Amendments to the Drawings (See Attachments)

Figure 1

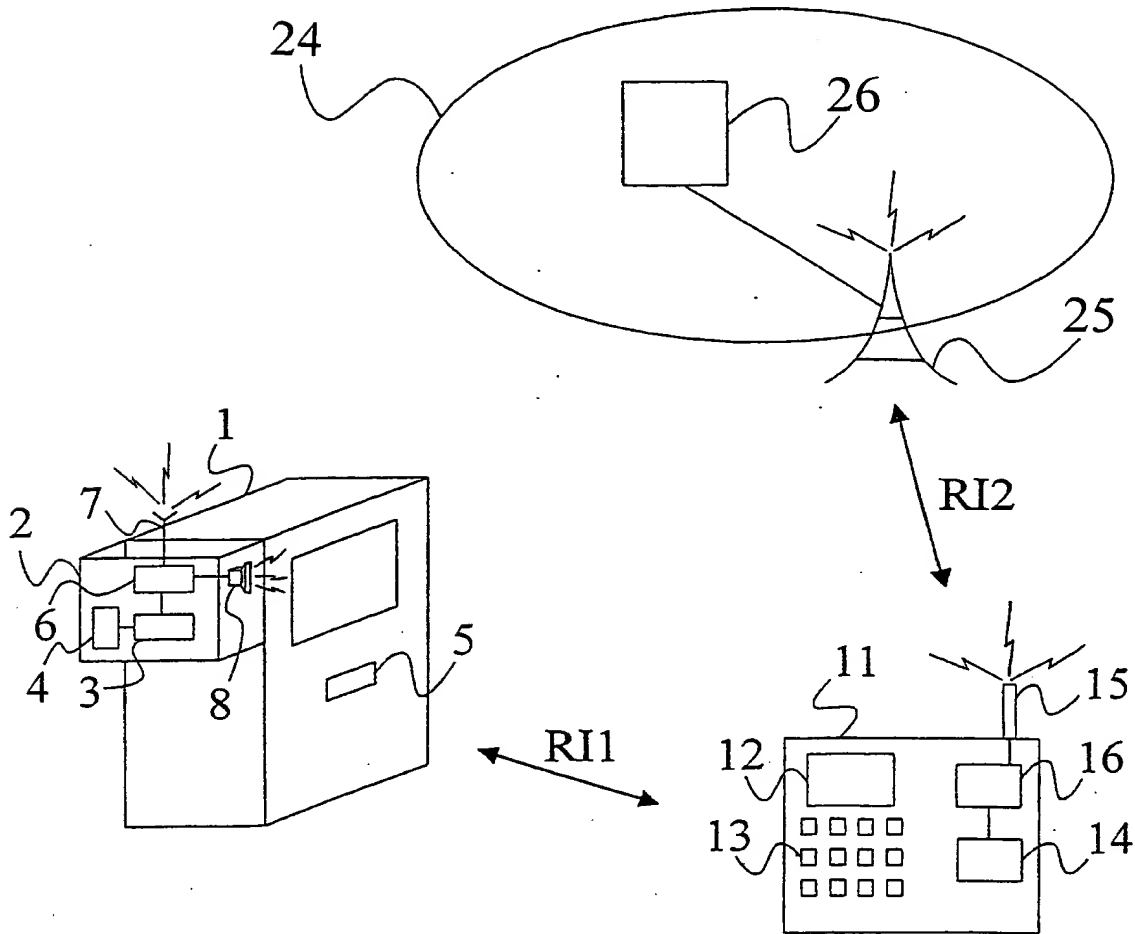
Please **REPLACE** Figure 1 of the drawings with amended Figure 1 on the attached sheet. In Figure 1, reference numerals 14, 15, and 16 for the cellular network, Base Station Subsystems, and Mobile Switching Centre, would be changed to reference numerals 24, 25, and 26, respectively.
